## MEMORANDUM

To: Town of Littleton Conservation Commission  
From: Dean Apostoleris, P.E.  
Kimley-Horn and Associates, Inc.  
Date: December 20, 2024  
Subject: RE: 151 Taylor St – NOI Resubmission

This memorandum shall accompany the applicant re-submission for NOI at 151 Taylor Street, dated December 20, 2024, for the review from the Conservation Commission. The applicant has appeared before the Conservation Commission prior on 08/20/2024 and 10/08/2024. It is requested that we are placed on the January 7, 2024 Conservation Commission agenda for discussion and consideration. The following items are included within this submission:

Figure B: Design Option #2 – Daisy-Chained Utility Transformers

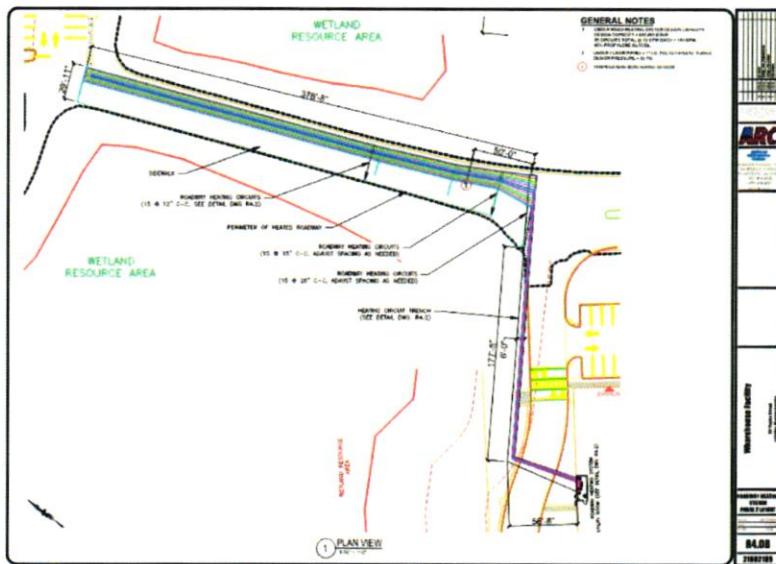
**Option #2:** Provide Secondary Service to the site that would energize the proposed EV infrastructure by "daisy chaining" the existing transformer with placement of another utility transformer within the parking lot as shown in Figure B. This options' impacts and challenges are as follows:

- Technically infeasible trench or bore across the heated causeway to the parking lot.
- As a result disturbance to not only the wetland buffers, but also  $\pm 4,000$  SF of impacts to the wetlands surrounding the heated causeway

- LELWD and Kimley-Horn determined in addition to more substantial wetland impacts this route does not meet utility standards or design/installation requirements
- no impacts to the trees around the Point of Intercept (POI).

Figure C: Heated Elevated Driveway Plan and Section Views

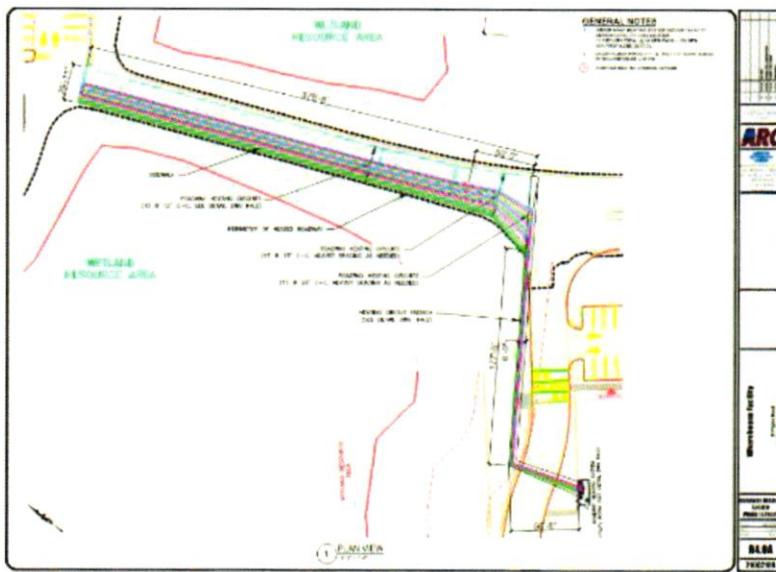
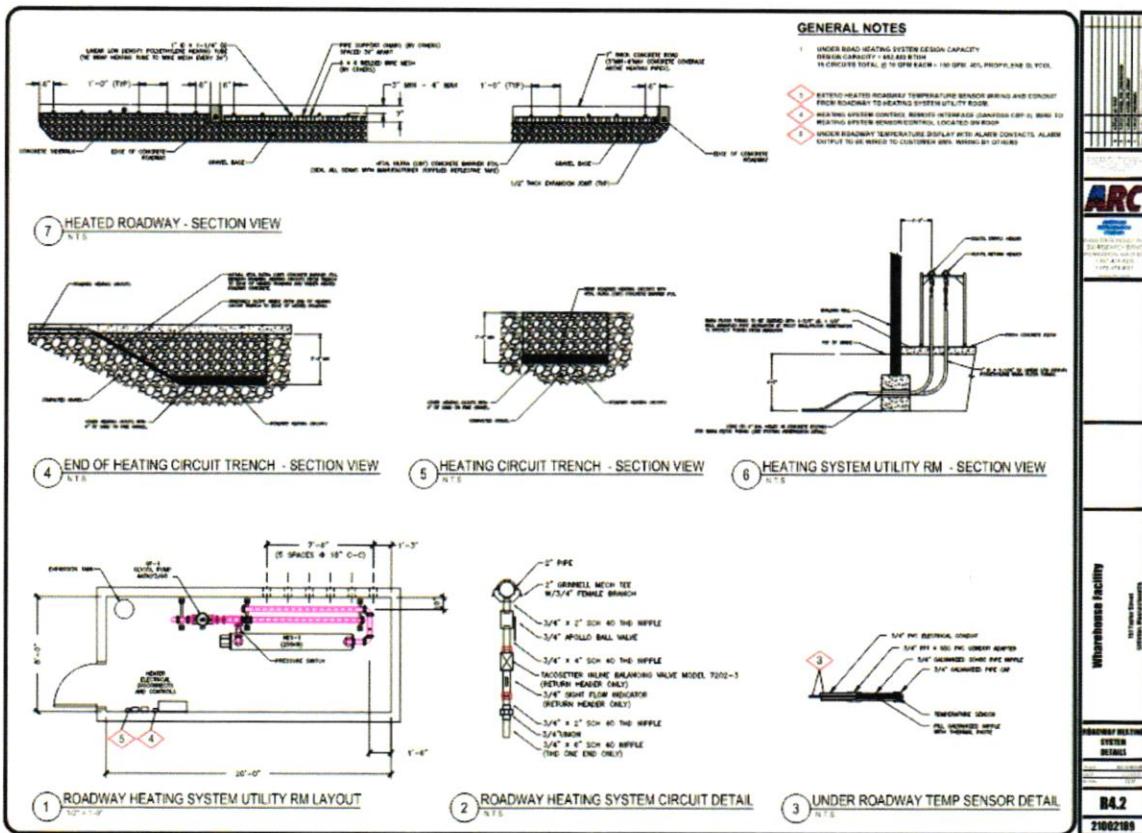
5. Provide more detail on what it would take to do the connection across the heated causeway and/or why its infeasible. If that route would require direct impacts in the wetlands or immediate buffer zone, provide an estimate on square feet of impacts for comparison to your preferred route

Design Options #1 and #2 are substantially impacted by the existing Heated Causeway System, which is a critical system to protect the wetlands on-site. Systems accelerates snow melt which limits the need for major roadway chemical or salt treatments immediately adjacent to the sensitive wetland and buffer area. The system as-builts included in this submittal and the excerpts shown in Figures C and D below confirm that the electrical route across the heated causeway is technically infeasible. This is true whether bored or trenched.

Horizontally, the entire paved causeway is filled with heating circuits and associated infrastructure. Vertically, the heating circuits are buried to a minimum depth of 42" below grade throughout the entirety of the causeway (details 4 and 5 on Sheet R4.2). The heated roadway itself is 7" thick and has circuits connect from the roadway itself to the heating circuits trench leaving conflicts from 0" to 42" deep below the approximate top of roadway elevation of 236'. This places the bottom of the heating circuits at elevation 232.5'. Deeper below the heating circuits is a 24" stormwater culvert with an approximate invert of 230' which makes the top of the culvert at elevation 232'. That leaves a maximum of 6" of cover between the top of culvert crossing perpendicular to the causeway and the bottom heating circuits traveling parallel to the heated cause way. The required 6" utility conduit would not fit with any required clearances between these two conflicts and cannot structurally hold that load without a minimum 12" or more concrete encasement around it. Further, a minimum bore reamer of 12" would be required to lead this route which would conflict either the culvert or the heating circuits.

In addition, if access to the conduit is needed for repairs, the entire heating circuit would need to be removed/replaced and access to the parking lot would be suspended during that time of repair impacting business operations and increasing runoff to the sensitive wetland area. LELWD (and most other public utilities) also do not allow impacts between public infrastructure (utility owned electrical) and private infrastructure (heated causeway heat elements) or allow private infrastructure within their easements, further causing this option to be infeasible.

**Response:** The infeasibility of boring or trenching across the heated causeway is described in the response to Comment #3 above. This is explained in the alternatives analysis and specifically under Options #1 and #2 and in Figures C and D.

Figure F: LELWD Well Pump Building Project Tie-in

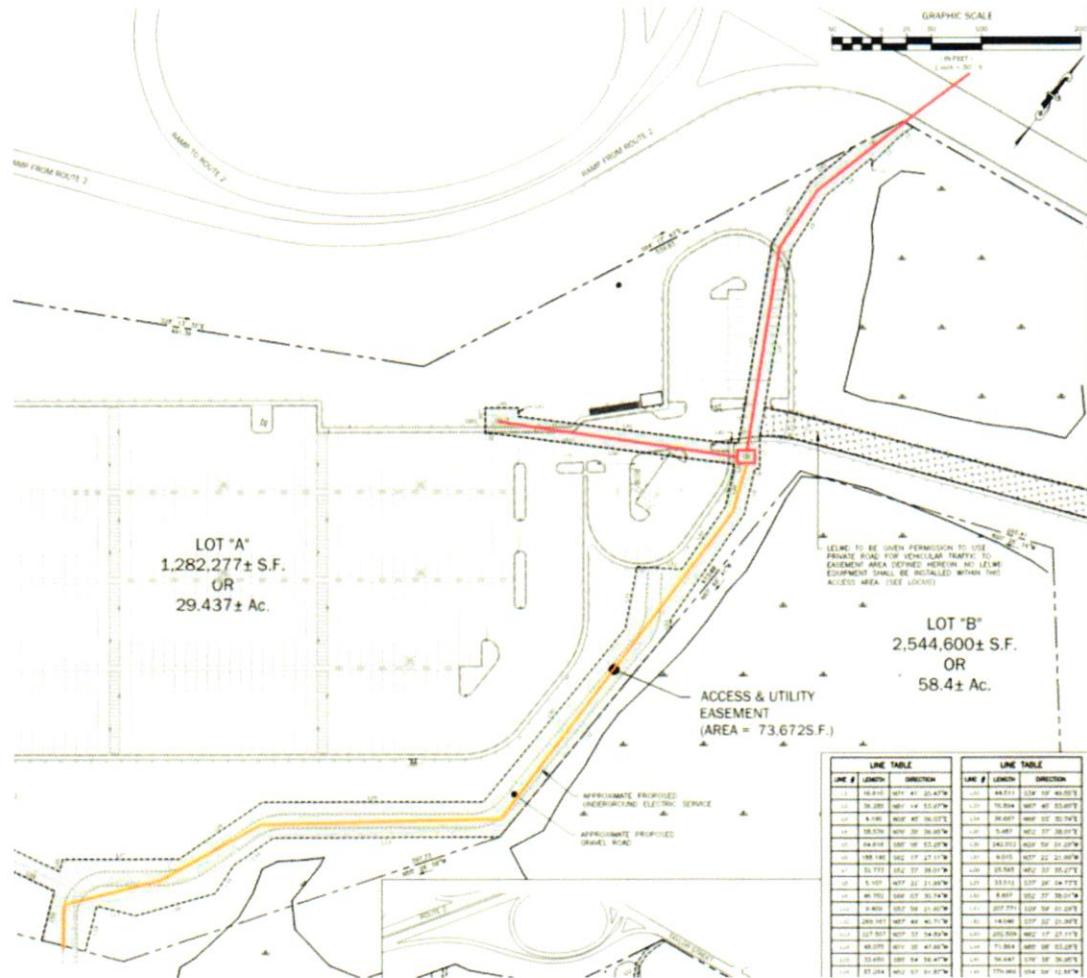
3. Provide alternative considerations for providing electrical infrastructure.

In further support of Option 3, a proposed Well Pump Building Project is being proposed by LELWD south of the subject site. This well project will draw power from the same utility medium voltage switch included in and the proposed application which limits impacts by combining two projects on a single electrical upgrade route. The routing in red shown below in Figure F shows the route of electrical upgrades included in this application and the routing in orange shows the future additional routing associated with the Well project.

Figure G: Bore Machine Specifications

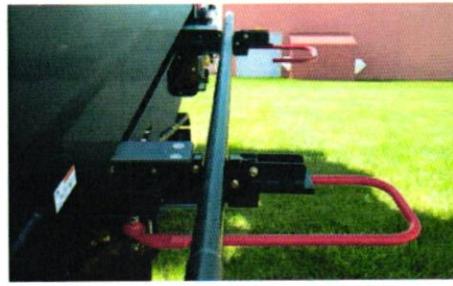
7. Describe the machinery being used to dig the easement, including where stockpiling might occur and control of runoff down the steep slope [usually accomplished with a Construction Sequence

**Response:** Please see Figure G "Bore Machine Specifications" below for a description of the machinery to be used for boring operations. Smaller trenching machinery, in addition to hand digging will be utilized for proposed trenching. Stockpiling will occur on the upstream side of the trench so that any runoff is controlled by the trench itself as well as the silt fence, filter sock and other measures as shown in the Erosion and Sediment Control Plan.

Overall, we believe boring would incur more substantial impacts to more trees and wetland buffers in this specific area. However, boring is utilized through the parking lot in order to reduce impacts to the buffers in areas that are not heavily wooded or with steep slopes.
